**REFERENCE:** C.N.97.1997.TREATIES-31 (Depositary Notification)

AMENDMENTS PROPOSED TO REGULATION NO. 91

**Economic and Social  
Council**Distr.  
RESTRICTEDTRANS/WP.29/531  
17 January 1997ENGLISH  
Original: ENGLISH  
and FRENCH**ECONOMIC COMMISSION FOR EUROPE****INLAND TRANSPORT COMMITTEE**Working Party on the Construction of Vehicles**DRAFT SUPPLEMENT 2 TO REGULATION No. 91**  
(Side-marker lamps)

Figure 1

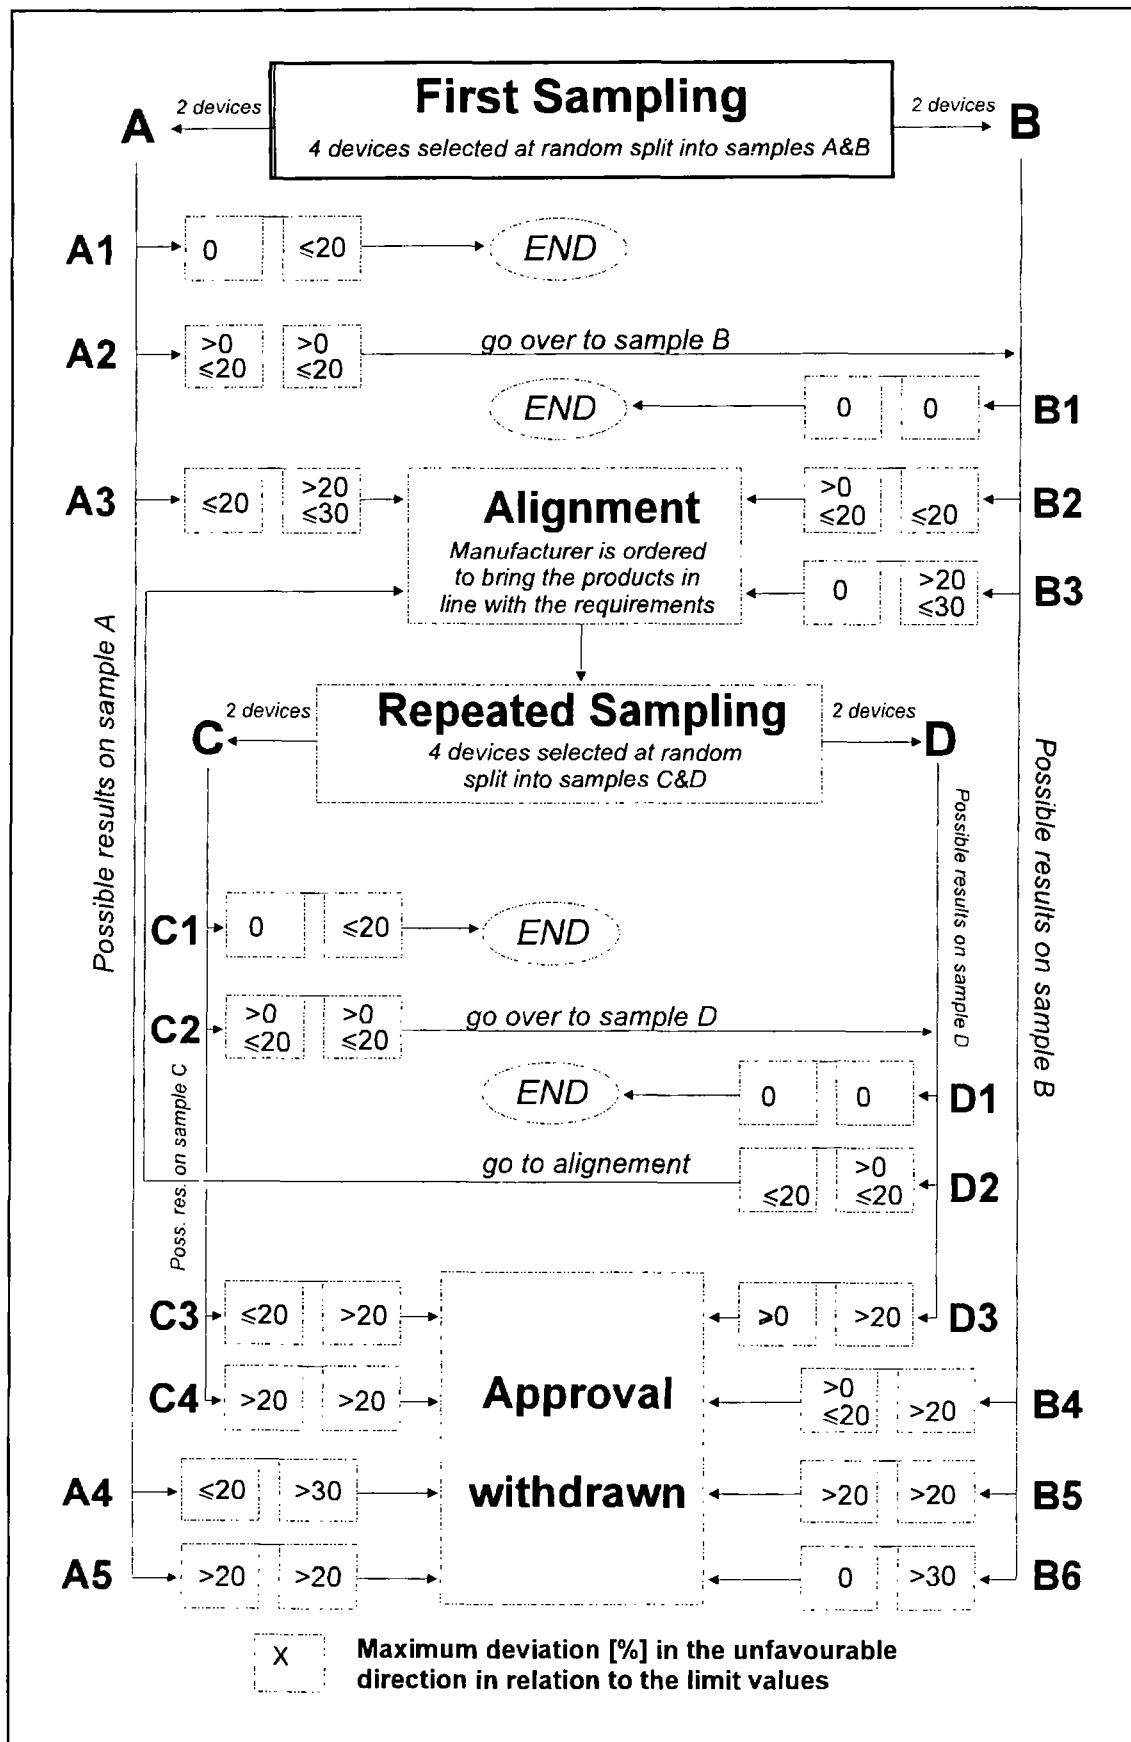
In the first sampling four side-marker lamps are selected at random. The first sample of two is marked A, the second sample of two is marked B.

- 2.1.1. Following the sampling procedure shown in Figure 1 of this annex the conformity of mass-produced side-marker lamps shall not be contested if the deviation of the measured values of the side-marker lamps in the unfavourable directions are:

- 2.2.1. Following the sampling procedure shown in Figure 1 of this annex the conformity of mass-produced side-marker lamps shall be contested and the manufacturer requested to make his production meet the requirements (alignment) if the deviations of the measured values of the side-marker lamps are:

Conformity shall be contested and paragraph 12 applied if, following the sampling procedure in Figure 1 of this annex, the deviations of the measured values of the side-marker lamps are:

In the cases of A3, B2, B3 a repeated sampling, third sample C of two side-marker lamps and fourth sample D of two side-marker lamps,

3.1.1. Following the sampling procedure shown in Figure 1 of this annex the conformity of mass-produced side-marker lamps shall not be contested if the deviations of the measured values of the side-marker lamps are:

3.2.1. Following the sampling procedure shown in Figure 1 of this annex the conformity of mass-produced side-marker lamps shall be contested and the manufacturer requested to make his production meet the requirements (alignment) if the deviations of the measured values of the side-marker lamps are:

Conformity shall be contested and paragraph 12 applied if, following the sampling procedure in Figure 1 of this annex, the deviations of the measured values of the side-marker lamps are:
